Access Compliance Report

Public Rights-of-Way

(Curb Ramps)

Intersection ID: 51443	Main Street: SHARON_RD	Cross Street: ASHLEY_PARK_LN	Location: NW
ADA ID: 059E20D4E5CA	Ramp Type: Directional1	Initial Pass/Fail: Fail	Overall Compliance: No
			Severity Score: 13.75

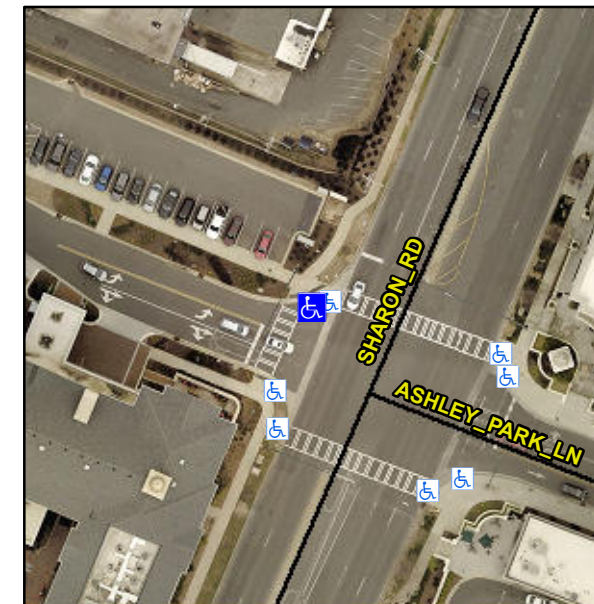
R304.2.2, R304.5.3

Compliance	Description	Data	Compliance	Description	Data
N/A	Ramp Length (in)	46.0	N/A	Grade Break?	N/A
Yes	Ramp Width (in)	84.0	N/A	Grade Break Slope (%)	0.0
No	Ramp Slope (%)	8.9	N/A	Grade Break XSlope (%)	0.0
No	Ramp XSlope (%)	2.5			
N/A	Flare Type LT	N/A	N/A	Flare Type RT	N/A
N/A	Flare Slope LT (%)	N/A	N/A	Flare Slope RT (%)	0.0
N/A	Flare Traversable LT?	N/A	N/A	Flare Traversable RT?	N/A
N/A	Landing Length (in)	0.0	N/A	DWS Provided?	N/A
N/A	Landing Width (in)	0.0	N/A	DWS Contrast?	N/A
N/A	Landing Slope (%)	0.0	N/A	DWS Length (in)	N/A
N/A	Landing X Slope (%)	0.0	N/A	DWS Full Width?	N/A
N/A	Landing Curb? (Y/N)	N/A	N/A	DWS Offset LT (in)	N/A
N/A	Shared Landing?	N/A	N/A	DWS Offset RT (in)	N/A
N/A	Gutter Ponding?	0.0	N/A	Gutter Slope (%)	N/A
N/A	Gutter Lip Ht (in)	0.0	N/A	Gutter X Slope (%)	N/A
N/A	Painted X Walk1?	Yes		Road Slope (%)	3.8
	X Walk 1 Direction	To S		Road X Slope (%)	1.4
	X Walk 1 Width (in)	108.0		Clear Space?	N/A

Remove & Replace Entire Ramp.
